AERONAUTICAL CHARTING MEETING
Instrument Procedures Group
Meeting 22-01 – April 25-26, 2022

FAA Control # 22-01-365

Subject: As Charted, Teardrop Course Reversals Lack Pilot Guidance on How to Fly the Reversal

ILS or LOC RWY 18 **PINEBLUFF RGNL/GRIDER FLD (PBF)**

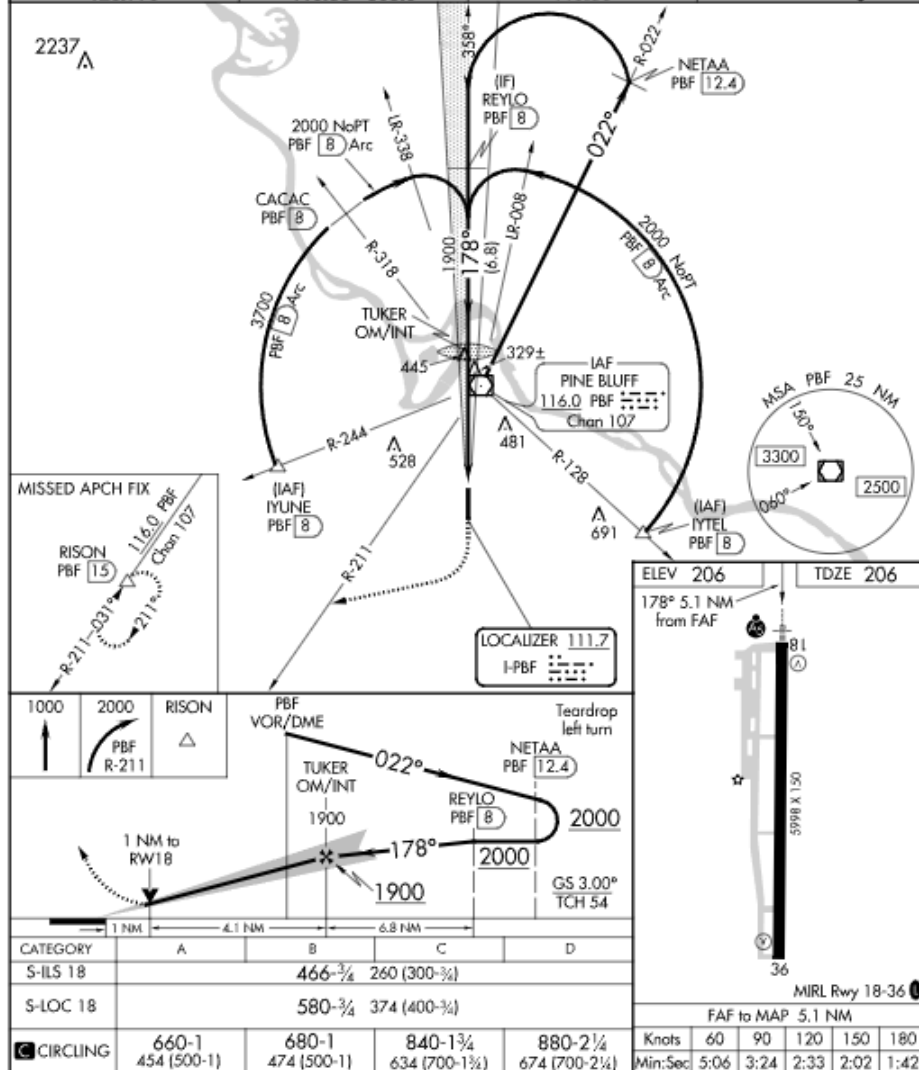
Problems may result from lack of guidance; for example, in PBF (full chart in Appendix A), there is no profile view “remain within” distance note for the teardrop. Without this note, the turn from NETAA to intercept the final is technically unbounded as there is no way to follow the depicted semicircle (when flying the approach with conventional navigation).

If charting continues to depict Teardrops as semicircles, provide pilots with AIM and/or IPH guidance equivalent to procedure turn, hold-in-lieu of procedure turn, and DME arcs.

Alternatively, change procedure design and/or charting to provide a navigable route line.
